Memorandum

Our ref: 948-011-016 Rev0

Re: **Response to review of comments on the Adaptive Management Plan for the Whale Tail Project, Submitted by Agnico Eagle Limited for Water Licence 2AM-WTP1830**

Figure 1: Temperature profile along Slope 5 below the cover system (4.7 to 9 m depth) (Okane, 2019).

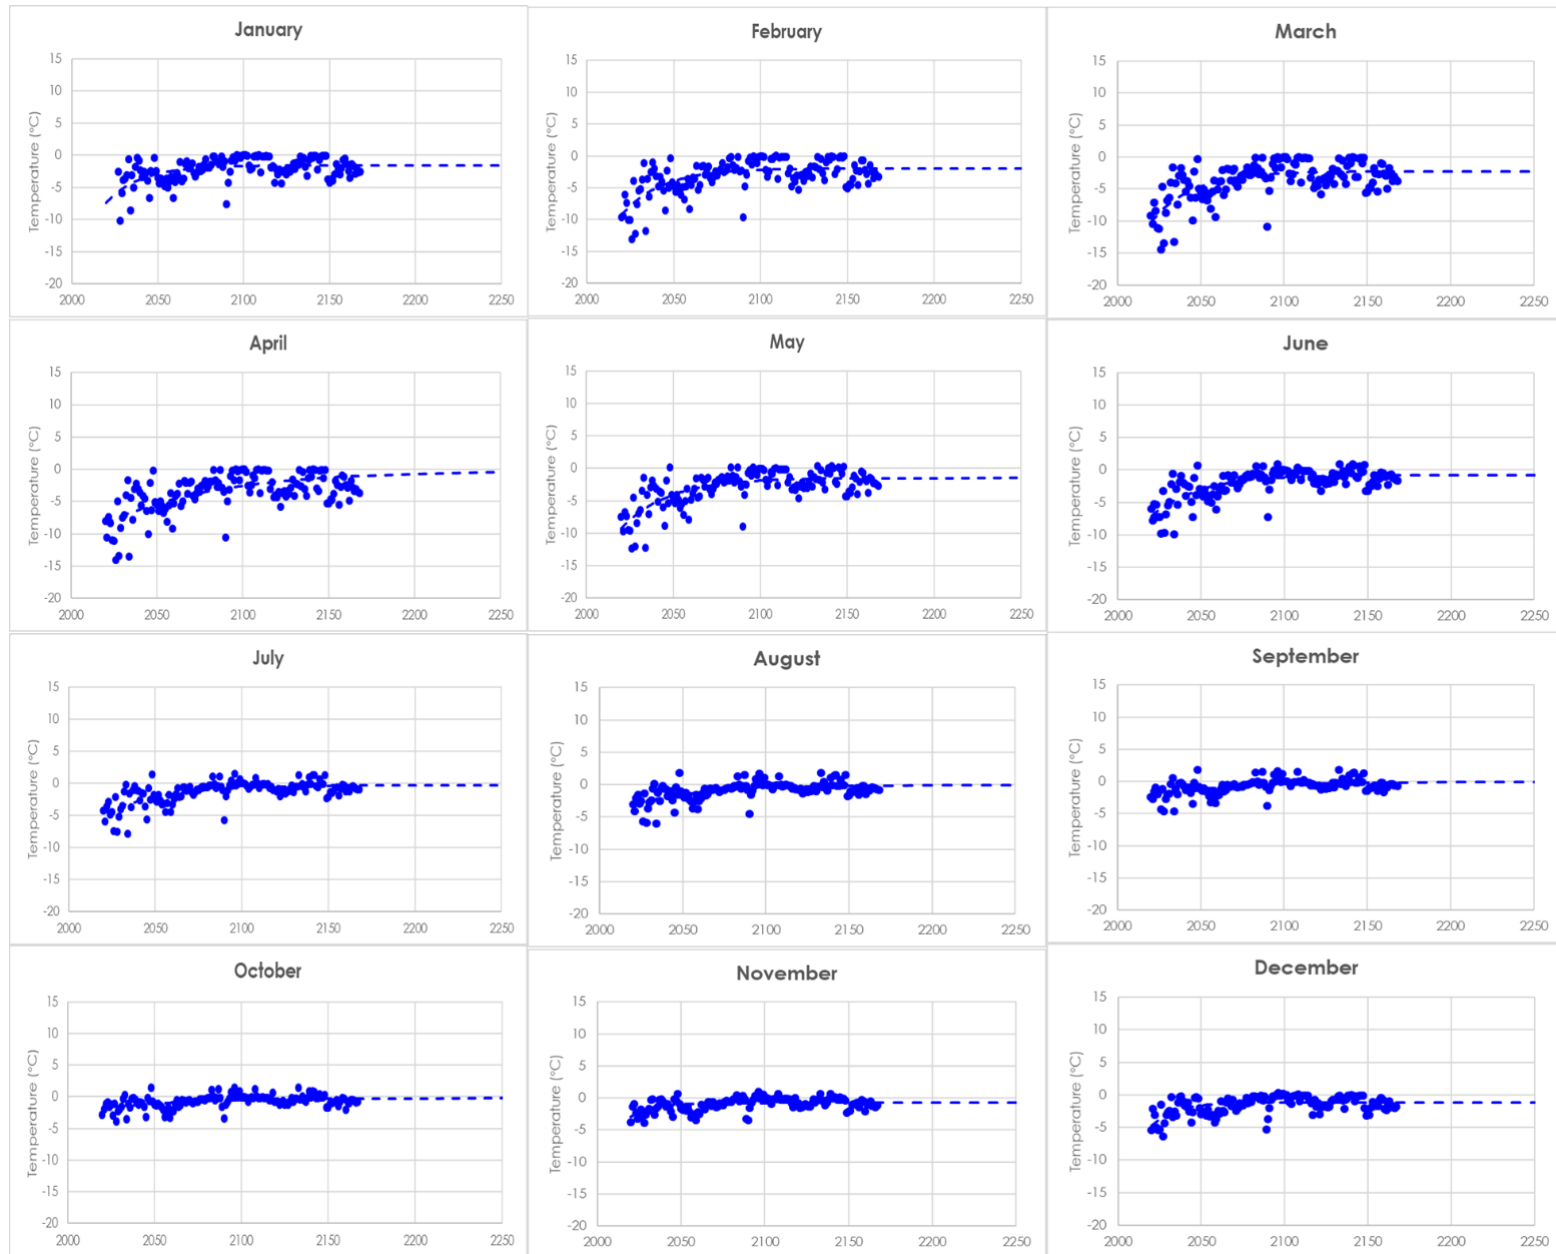
Okane Consultants Inc. (Okane) received a copy of Mr. David Zhong's April 30, 2021 letter regarding Crown-Indigenous Relations and Northern Affairs Canada (CIRNAC) review of responses to comments on the Adaptive Management Plan for the Whale Tail Project, Submitted by Agnico Eagle Limited for Water Licence 2AM-WTP1830¹. Agnico Eagle Mines Ltd. (Agnico Eagle) has requested that Okane provide additional clarification in regard to CIRNAC's comment #4:

The monitoring depth of 7 m for the waste rock storage facilities (WRSFs) was selected as a threshold in the Adaptive Management plan as it is explicitly expected to remain beyond the active layer zone. The active layer is defined as the depth to which annual freezing and thawing is observed (i.e. the maximum depth of thaw above 0°C). The active layer is highly variable on an annual basis due to inter-annual climate variability. Thus monitoring temperature conditions slightly beyond the expected active layer is

The 7 m threshold was selected with consideration given to long term thermal and seepage modelling conducted under RCP8.5 climate change conditions (Okane, 2019²) which was submitted in support of the December 2019 submission package to the Nunavut Water Board (NWB). The threshold was not selected based on modelling results of the expected active layer depth under RCP8.5 conditions. Under RCP8.5 conditions, modelling indicates that the average active layer depth will be less than 7 m. Figure 12 from Okane, 2019², where expected average temperature at approximately 7 m below surface is shown for a south facing slope near the toe of the WRSF is appended for ease of reference. This location is expected to have the highest likelihood of infiltrating water transporting any potential contaminants of concern away from the WRSF landform. Long term, this depth is expected to remain below 0°C.

Additionally, the thermal cover system design basis indicates a required minimum cover system thickness of 4.7 m. It is worth noting that along the slopes of the WRSF (locations most susceptible to transporting any potential contaminants of concern away from the WRSF landform due to the expected hydrology of the WRSFs) the cover system thickness ranges between 4.7 m and 7.7 m. The assumed proportion of contact vs. non-contact interflow water expected to report from the WRSF was based on a nominal 4.7 m cover system thickness resulting in a high degree of conservatism in inputs from the WRSF thermal and seepage modelling to the site-wide water quality model.
